**Meghan Pump Station (RFCSP)  
Solicitation Number: CO-00645  
Job No.: 19-1006**

**ADDENDUM 2  
October 17, 2023**

BOOSTER PUMP DETAILS

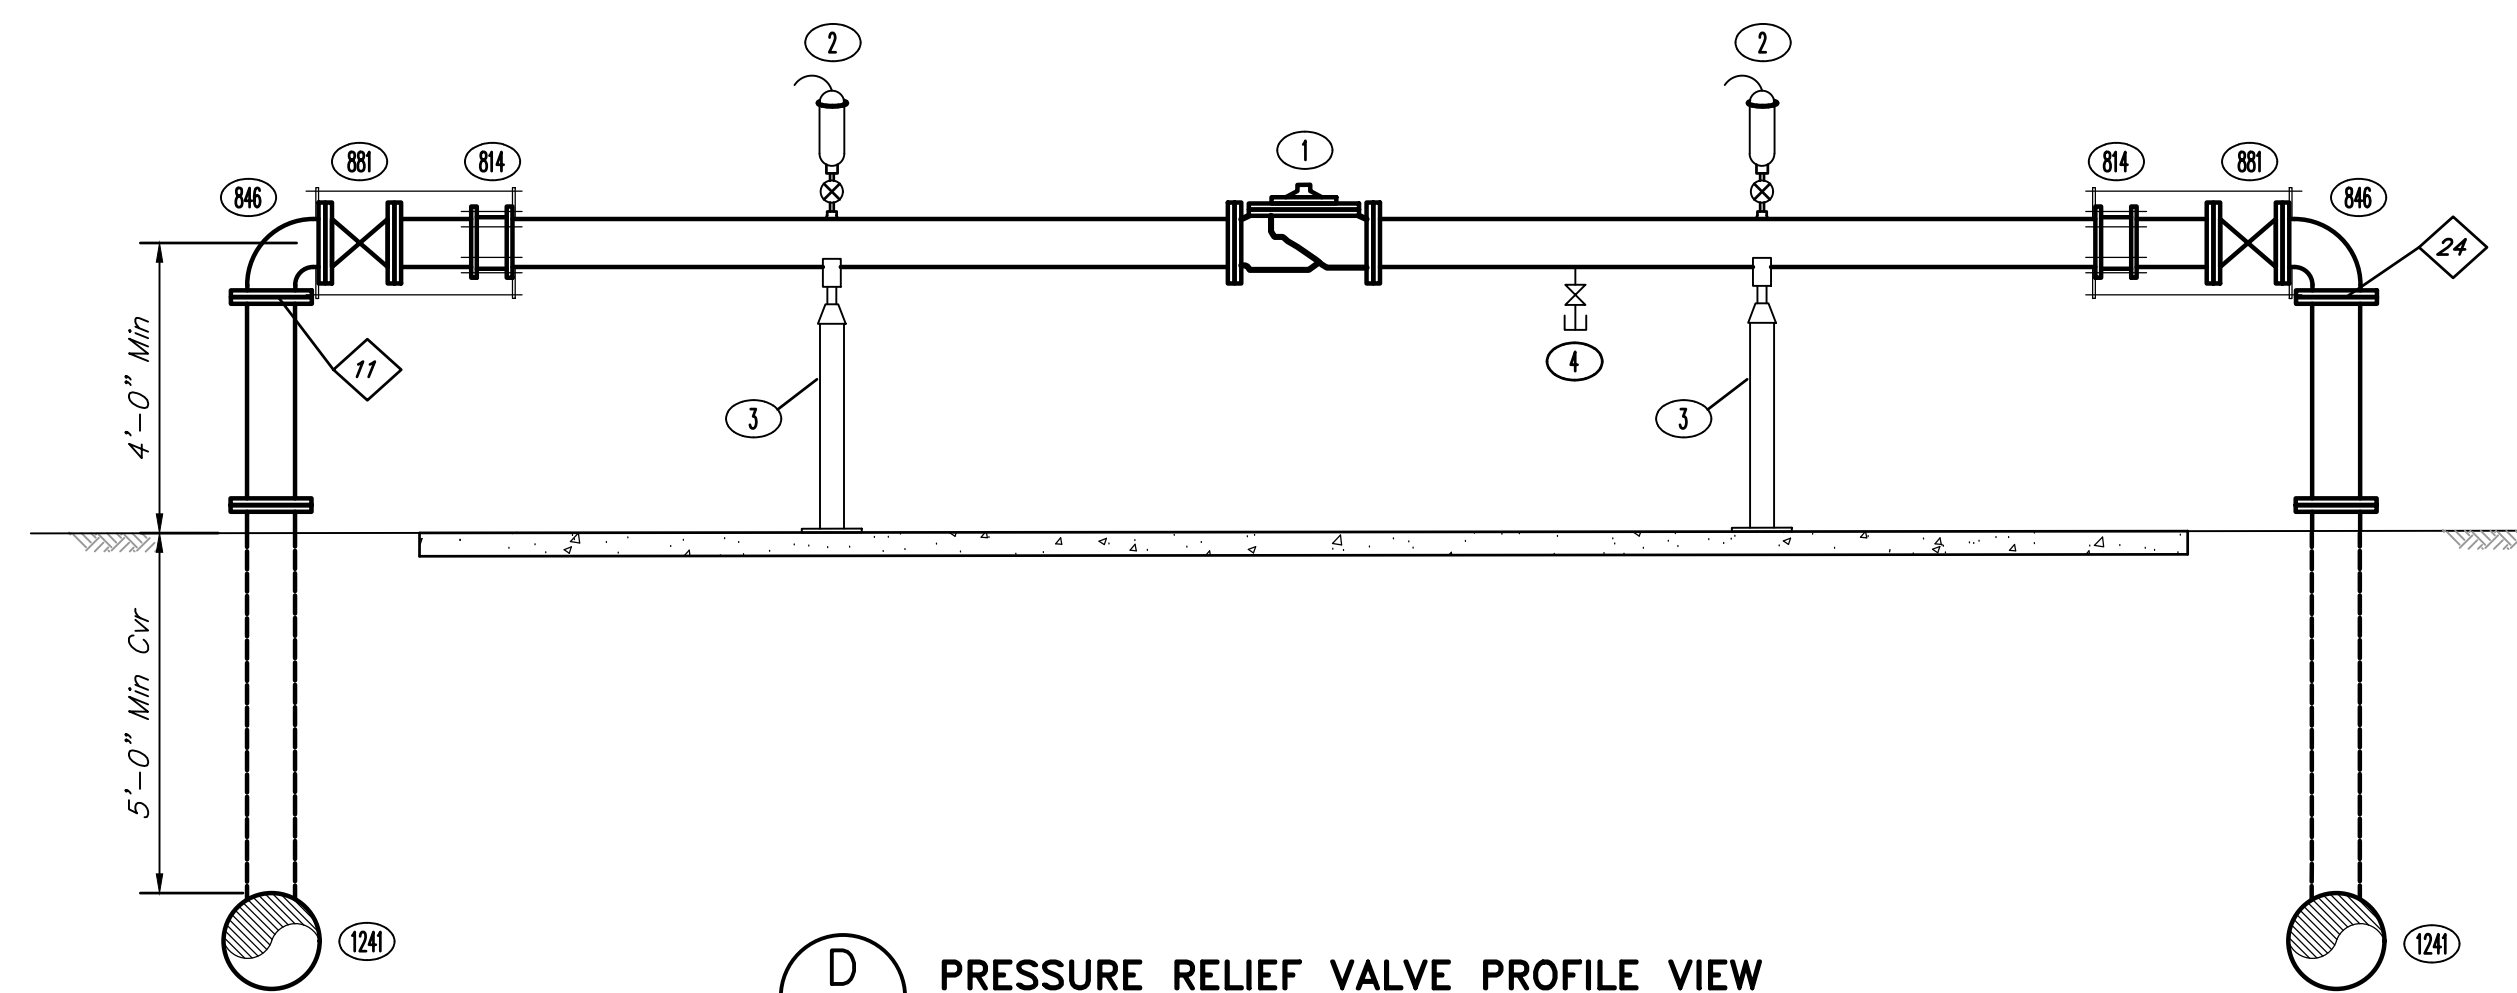
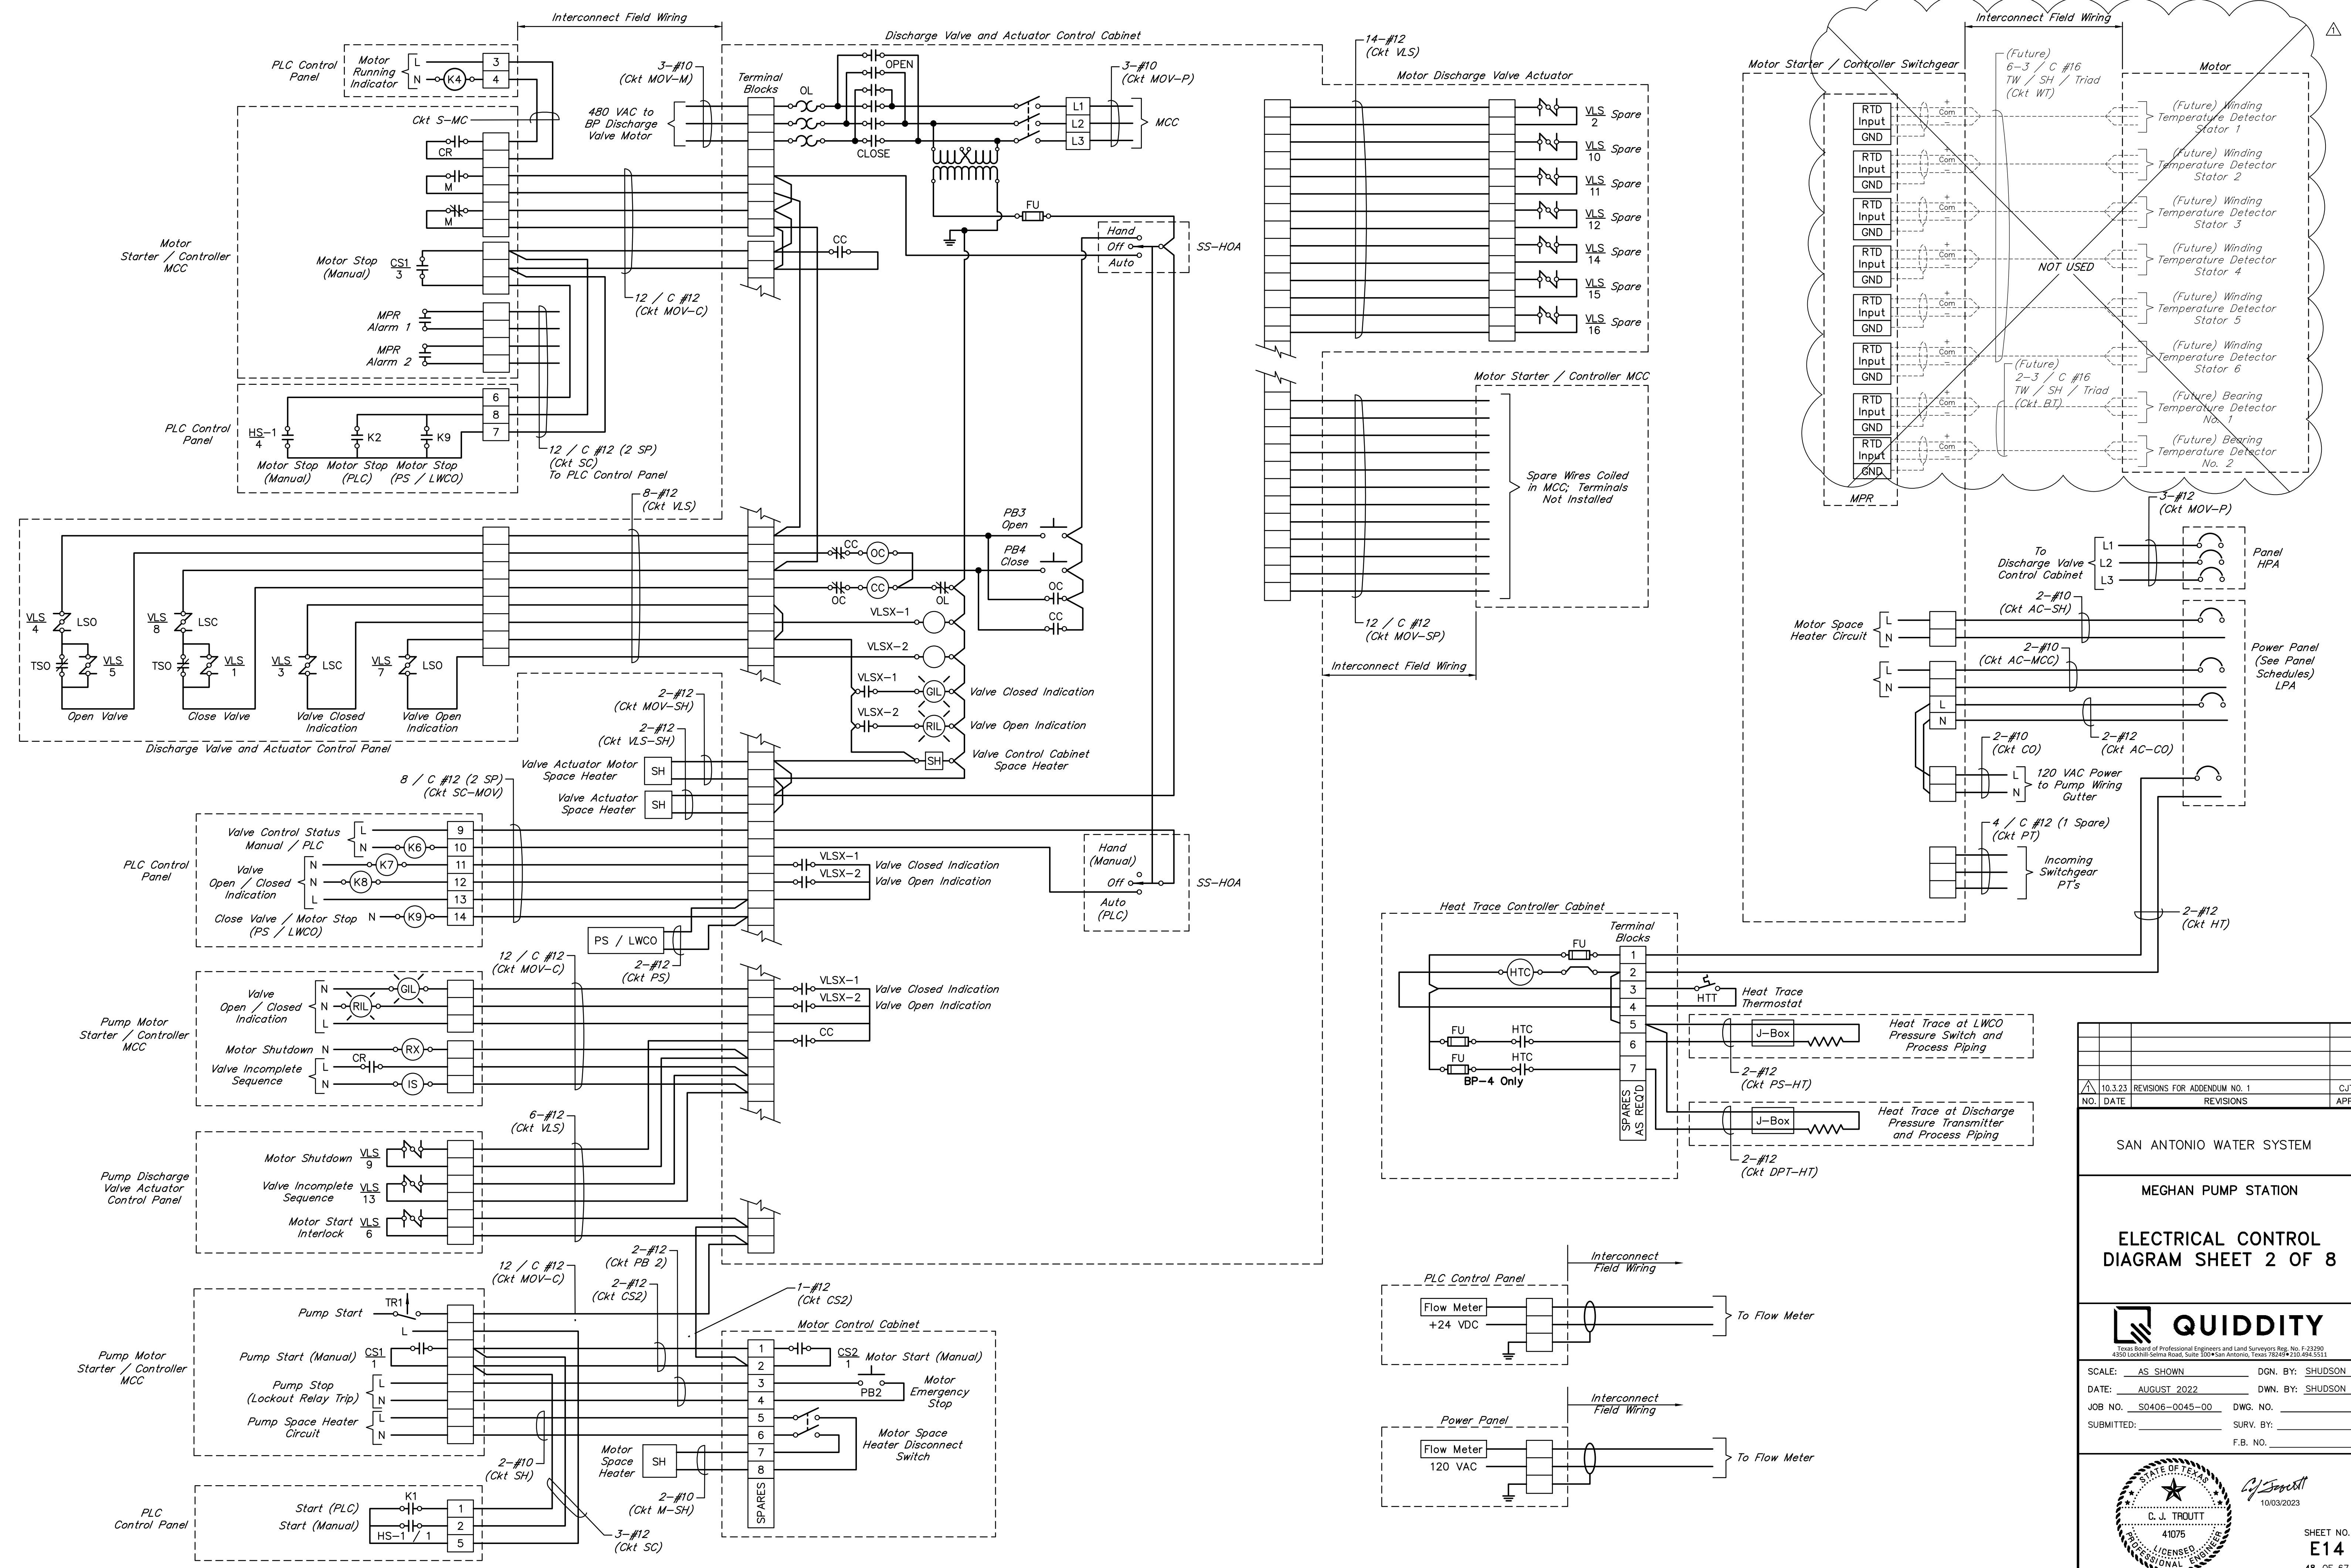
37. M4: Detail Drawing B is inaccurate. Motor is labeled Accessory Item #10 which indicates 125HP unit. The discharge line is 8", which is in conflict with how this unit is shown on M3 and described in pump specification. It is believed this Detail B should be showing Accessory Item #9, and correspond with unit tag BP-03-101.

38. M4: Detail drawings show a large object that looks like a bowl stage overlaid on pump can profiles. Please remove to avoid confusion.

*Response: See #2, Changes to the Plans, in this addendum. The indicated revision to Sheet M4 has been made.*

*Response: See #2, Changes to the Plans, in this addendum. The indicated revision to Sheet M4 has been made.*
